SUBJECT: WATTS BAR NUCLEAR PLANT - RESPONSES TO REQUEST FOR
ADDITIONAL INFORMATION (RAI) REGARDING TRITIUM PRODUCTION -
INTERFACE ITEM NUMBERS 1, 6, 7, 10, 11, AND 12 (TAC NO. MB1884)

ENCLOSURE 1
TENNESSEE VALLEY AUTHORITY
WATTS NUCLEAR PLANT (WBN)
UNIT 1
DOCKET NO. 390
RESPONSE TO NRC REQUEST FOR ADDITIONAL INFORMATION

FIGURE 1
WBN ALLOWABLE SFP DECAY HEAT FOR
OFF-DESIGN SFPCS HX FOULING AND CCS TEMPERATURES

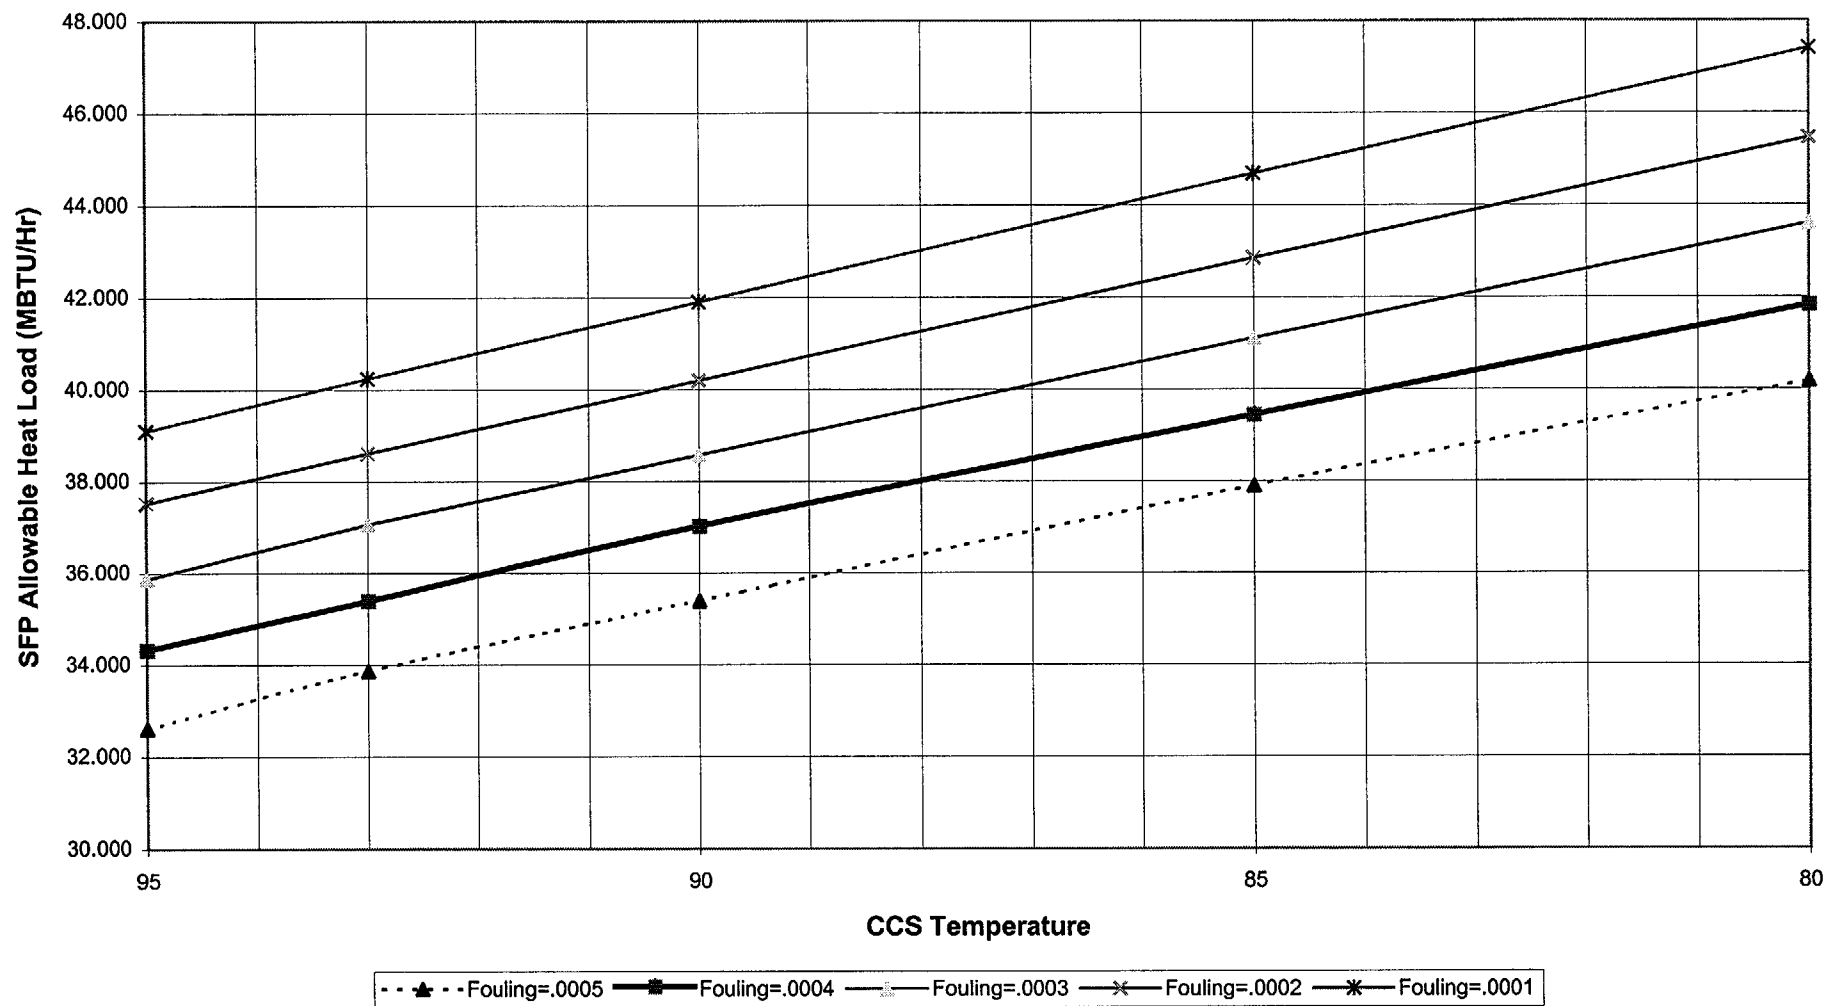
- c) In the subsection "Results of Alternate Analysis", TVA states that "series of curves have been developed to provide operator guidance for an increase in allowable SFP decay heat." What criteria were used to determine the allowable decay heat for the given heat exchanger fouling and CCS temperature when preparing the curves? Is each point in the curves the maximum decay heat which would maintain the SFP temperature below 159.24°F for the given heat exchanger fouling and CCS temperature? Please provide this graph.

The Alternate Analysis developed data for the curves by placing just enough decay heat load into the SFP that would result in a maximum SFP temperature of 159.24°F, assuming one failed train of SFP cooling. Multiple analyses were performed at varying fouling factors, ranging from 0.0001 to 0.0005 and varying CCS Temperatures between 95°F to 80°F. As expected, at lower fouling and lower CCS temperature, a higher quantity of SFP decay heat could be input without exceeding the design limiting SFP temperature of 159.24°F. The resulting data was reduced by 2% to include margin, and the reduced data points were subsequently graphed (See attached Figure 1.) to allow a varying maximum SFP decay heat based on actual fouling and CCS temperatures.

FIGURE 2
TRITIUM IMPACT ON OFF-LOADING DECAY HEAT

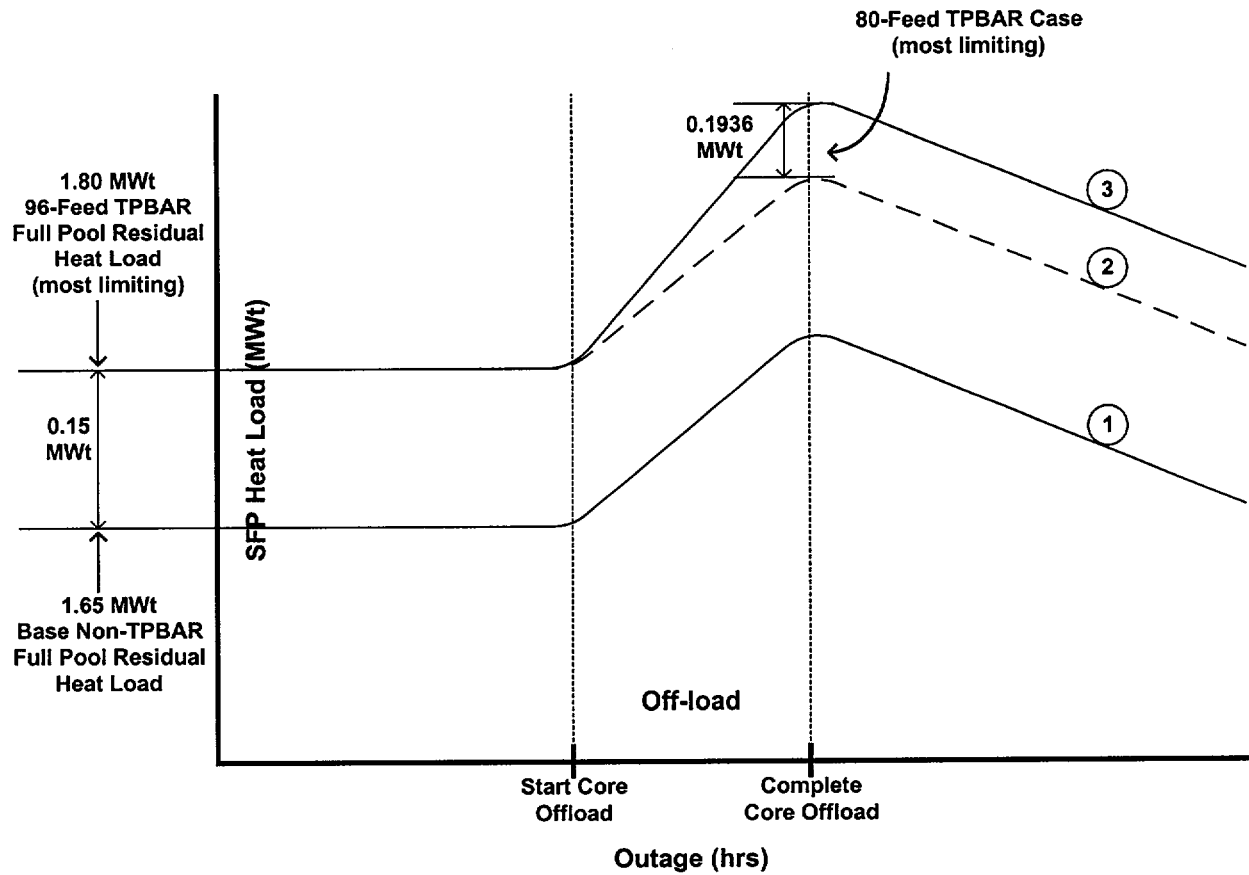
1. In the sub-sections "Tritium Impact on Spent Fuel Pool Decay Heat" of Section 1.5.8 (Station Service Water System) and Section 1.5.12 (Component Cooling Water System [CCS]), TVA referred to "a quantitative analysis of expected spent fuel decay heat." Please provide this analysis or a summary of the analysis, which should include the scenarios evaluated, the methodology, the code used, important assumptions and results.

A graphical representation of the limiting 80-Feed TPBAR core decay heat case and the limiting 96-Feed TPBAR SFP residual decay heat case is found in Figure 2. This diagram shows Tritium's impact on off-loading activities.

1. Current Trajectory with out Tritium - Starting at 1.65 MWt
2. Trajectory on Non-TPBAR Core During Off-load, if Starting @ 1.80 MWt
3. Trajectory of the 80-Feed TPBAR Case Starting at Full SFP Condition
